**RE: Response to Comments
Disapproval - SWMU-1 Closure Plan
Western Refining Southwest Inc., Gallup Refinery
McKinley County, Gallup, New Mexico
EPA ID# NMD000333211**

**MPC RESPONSE TO NMED COMMENTS FOR THE “DISAPPROVAL SWMU 1 CLOSURE
WORK PLAN” (DECEMBER 14, 2021)**

**SWMU-1 CORRECTIVE MEASURES IMPLEMENTATION WORK PLAN
(FORMERLY THE SWMU-1 CLOSURE PLAN)**

2 TYPICAL GROUNDWATER COLLECTION TRENCH SECTION
SCALE: NONE

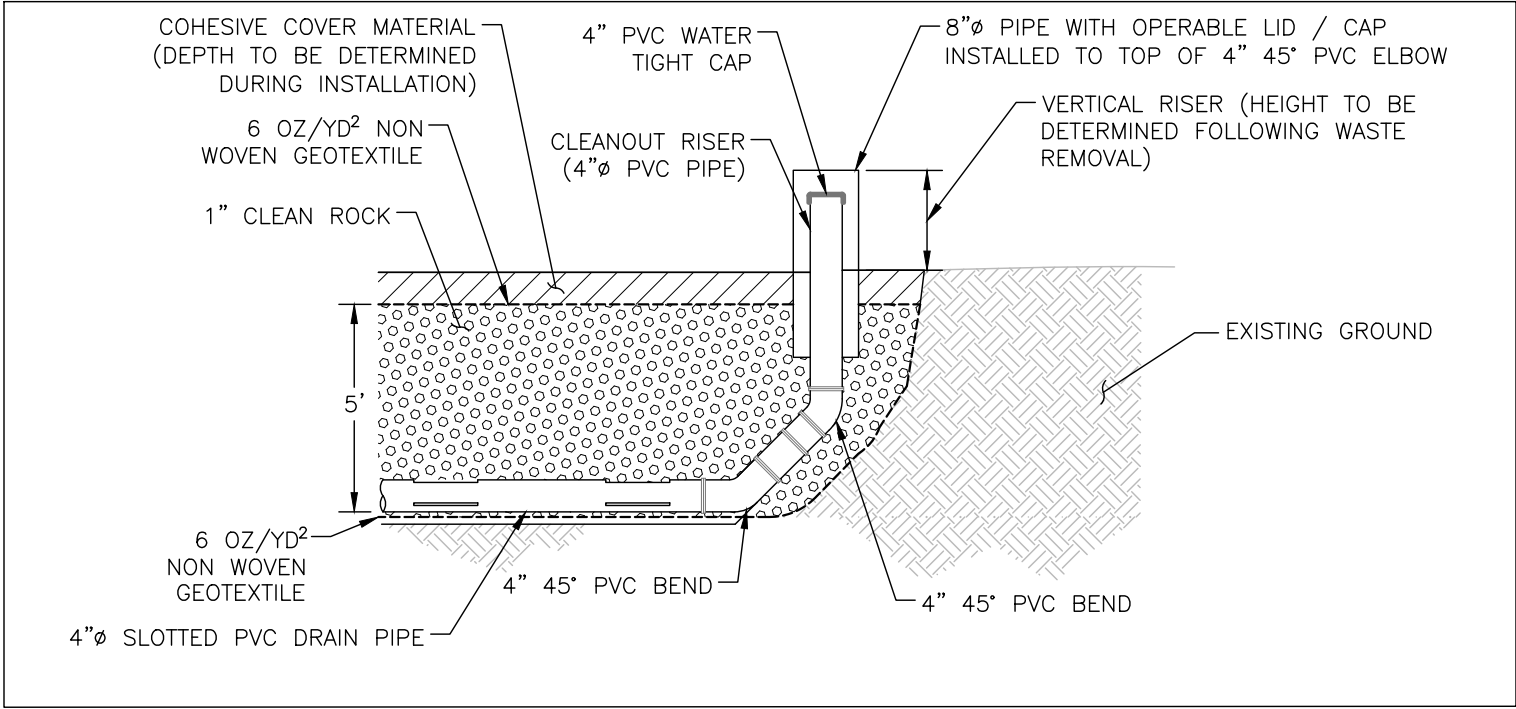
NMED General Comment	MPC Response
<p>Comment 18:</p> <p>In Section 5.4 (Installation of Groundwater Interceptor Trenches for Future Control of Groundwater), page 28 of 34, paragraph 3, the Permittee states, "[b]ased on the depth of local groundwater, the expected depth of this excavation is approximately 4 to 5 ft bgs at the bottom of the excavation. A cross section of the interceptor trench is also shown on Drawing Sheet 4." According to Drawing Sheet 4, the trench depth is designed to be five feet below the existing ground surface. The gauging data collected from the NAPIS and KA wells indicate that the depth of groundwater would be deeper than five feet below groundwater surface (bgs) at the location. Therefore, groundwater will not likely be intercepted at the proposed depth of the interceptor trench (5 feet bgs). The depth of the interceptor trench must be lower than the depth of the excavation or the historic water table at a minimum. Revise the proposed depth of the trench to ensure that groundwater is intercepted in the revised Closure Plan.</p>	<p>Response 18:</p> <p>The referenced section (Installation of Groundwater Interceptor Trench for Future Control of Groundwater) is now numbered 5.5 (page 31 of 38).</p> <p>Drawing Sheet 4 – cross-section of interceptor trench detail was modified so that the depth is five feet below the final excavated surface. This will lower the effective depth of the trench to approximately 10 feet below the existing ground surface.</p>

Following excavation of the waste in AL-1 and EP-1, a groundwater interceptor trench may be installed on the eastern, upgradient side of SWMU-1 in the location shown on Drawing Sheet 3 to reduce the potential of impacted groundwater contacting clean backfill in the area. The proposed groundwater interceptor trench will

be installed if deemed necessary dependent on site conditions and if the excavation is deep enough to intersect groundwater. Based on the depth of local groundwater, the expected depth of the trench is approximately 5 ft bgs at the bottom of the excavation. The trench, if needed, would be constructed at the bottom of the final excavated surface. A cross section of the interceptor trench is shown on Drawing Sheet 4. During backfill, a sump will be installed into the interceptor trench, which will consist of 4-inch polyvinyl chloride pipe. This sump will be brought to the surface to allow access for pumping of the trench, if groundwater levels indicate that this is required. Groundwater from these sumps will be tied into the permanent groundwater recovery system (Phase 2) that is scheduled for completion in 2023.
